Office Action Summary	Application No. 10/813,886	Applicant(s) ZHANG ET AL.	
	Examiner Jennifer Matisiak	Art Unit 2811

DETAILED ACTION

FIG. 3C

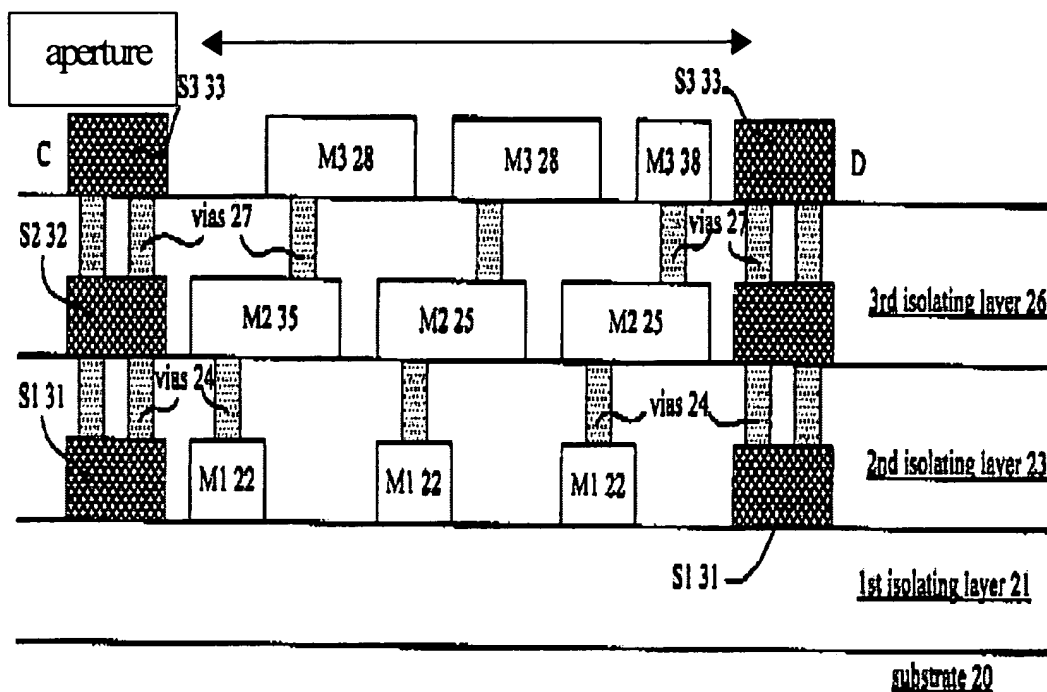
Regarding claim 1, Liou discloses an apparatus (Fig. 3C, for example) comprising: an inductor (M1 22, M2 25, M3 28, 21, 23, 26); and an electrically conductive enclosure (S1 31, S2 32, S3 33) electromagnetically shielding the inductor, the electrically conductive enclosure having an aperture (see figure below) at least as large as the inductor, the aperture being substantially centered around a projected surface of the inductor.

Regarding claim 2, Liou discloses an apparatus wherein the aperture is substantially parallel to a plane of current flow in the inductor (Fig. 3C).

Regarding claim 8, Liou discloses an apparatus (Fig. 3C) wherein the electrically conductive enclosure (S1 31, S2 32, S3 33) includes a top plate (S3 33), a bottom plate (S1 31), and sidewalls (S2 32).

Regarding claim 10, Liou discloses an apparatus (Fig. 3C) wherein the aperture is formed in the bottom plate (S1 31).

FIG. 3B

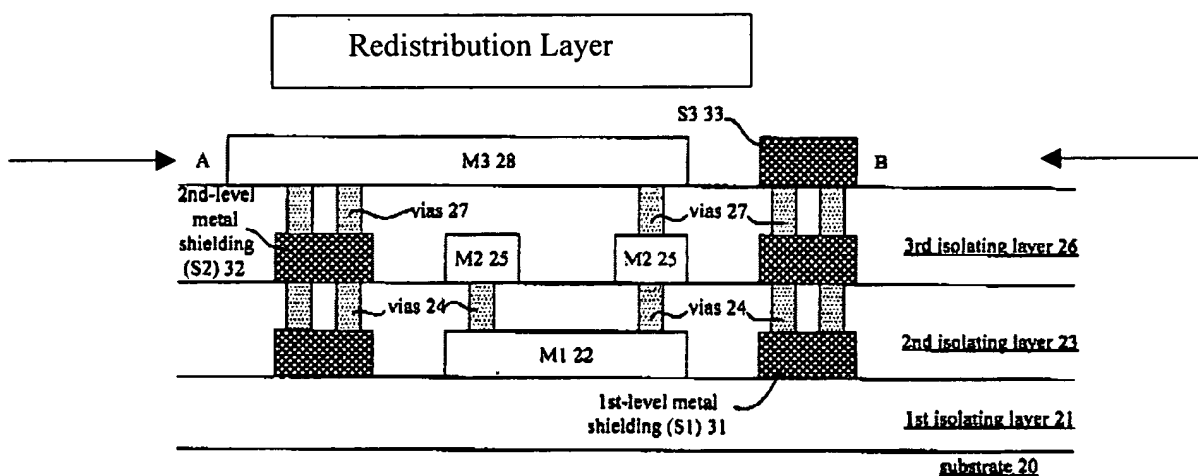
Regarding claim 13, Liou discloses an apparatus (Fig. 3C) wherein the top plate (S3 33) is formed in a redistribution layer (see figure below, col 3, lines 59-62).

Regarding claim 16, Liou discloses an apparatus (Fig. 3C) wherein the inductor (M1 22, M2 25, M3 28, 21, 23, 26) is formed at least partially in one or more redistribution layers (see figure above) formed on an integrated circuit die.
